Model : P75/55IMx

Intel Merom CPU + PM965 + ICH8-M Chipset
Santa Rosa plantfrom (No supported AMT)

Revision History		
	08/2006	Initial Rev.RA
	09/2006	Rev.A1
	11/2006	Rev.A2
	01/2007	Rev.B
	03/2007	Rev.C

UNIWILL COMPUTER CORP.			
Title		P75/55IMx	
Size	Document Number	INDEX	Rev C
	3581		
Date:	Tuesday, March 13, 2007	Sheet	1 of 37

USB PORT CONN

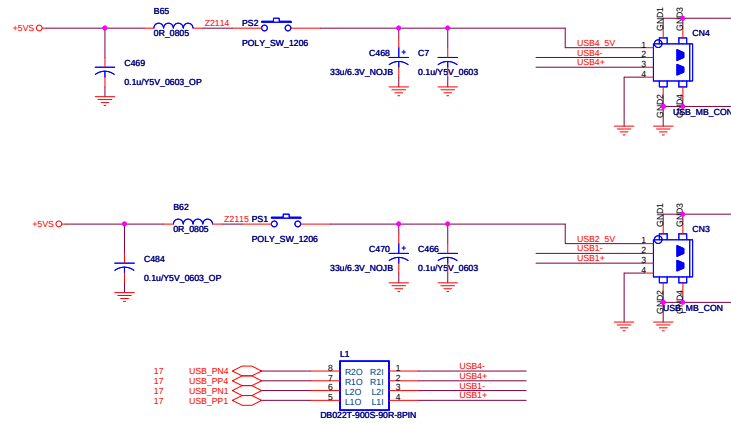
USB CONN change from 3 ports to 2 ports @ REVA2
One USB ports w/I charger remove to daughter board and add eSATA port@ REVA2
